SUBJECT: FORT CALHOUN STATION- NRC COMPONENT DESIGN BASES INSPECTION
REPORT 05000285/2009006

Report Nos.: 05000285/2009006

Facility: Fort Calhoun Station

IR 05000285/2009006; August 24-28, 2009, and September 8-18, 2009; Fort Calhoun Station: baseline inspection, NRC Inspection Procedure 71111.21, Component Design Basis Inspection.

Figure 1

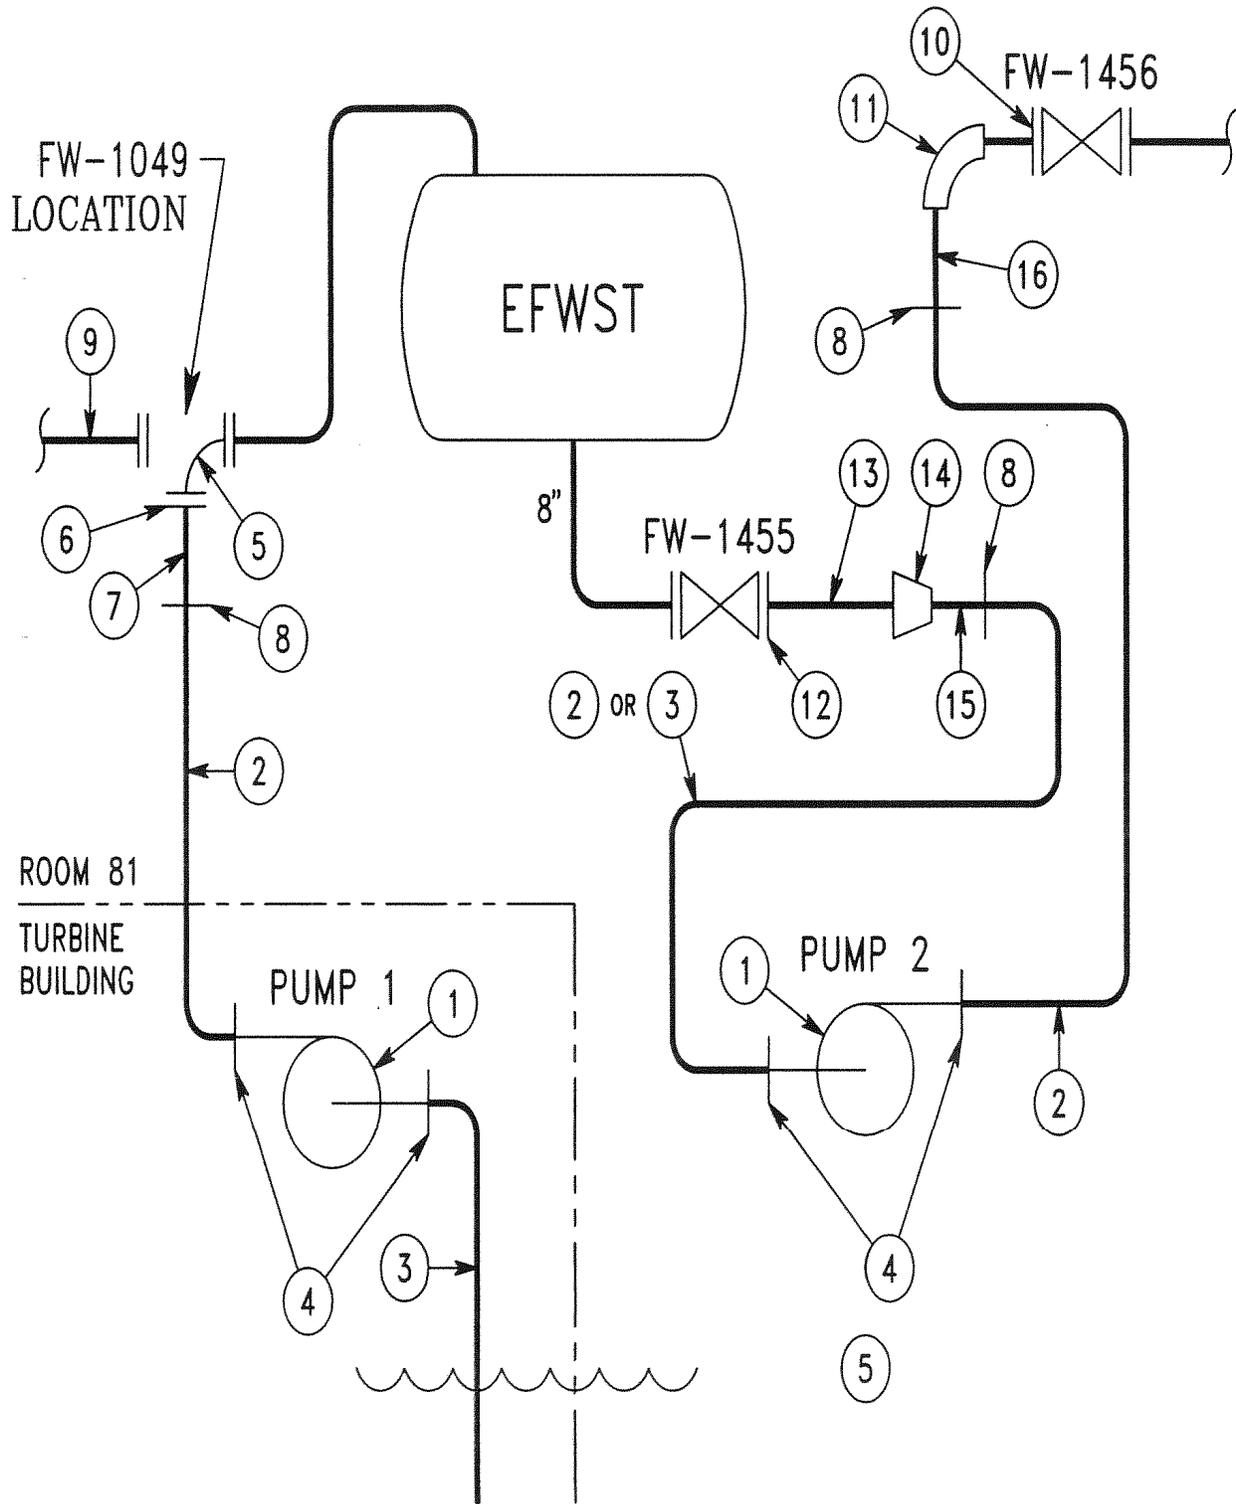
Procedure PE-RR-AE-1002 directs the installation of two portable gasoline engine-driven pumps as shown in the drawing in Figure 1. The first pump takes a suction directly on the flood waters in the turbine building via a suction strainer and fills the Emergency Feedwater Storage Tank via fire hoses and a permanently installed process flange. The second pump takes a suction from the tank via a second flange, and pumps to the steam generators through hoses, fittings, and flanges to the feedwater system.

Figure 2

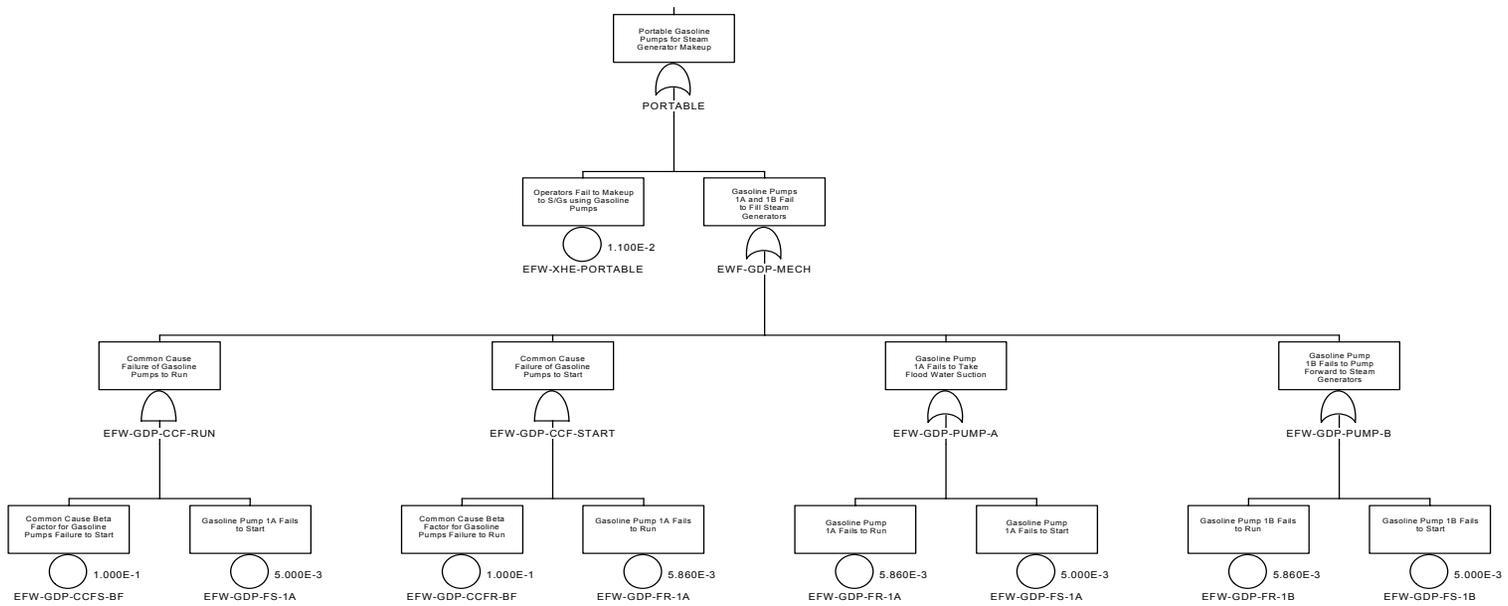
The analyst solved the fault tree, shown in Figure 2, and determined that the probability that this alternate mitigation strategy would fail was 3.23E-02. Because this strategy would be available regardless of the performance deficiency, the analyst multiplied both baseline and case conditional core damage probabilities by this value.
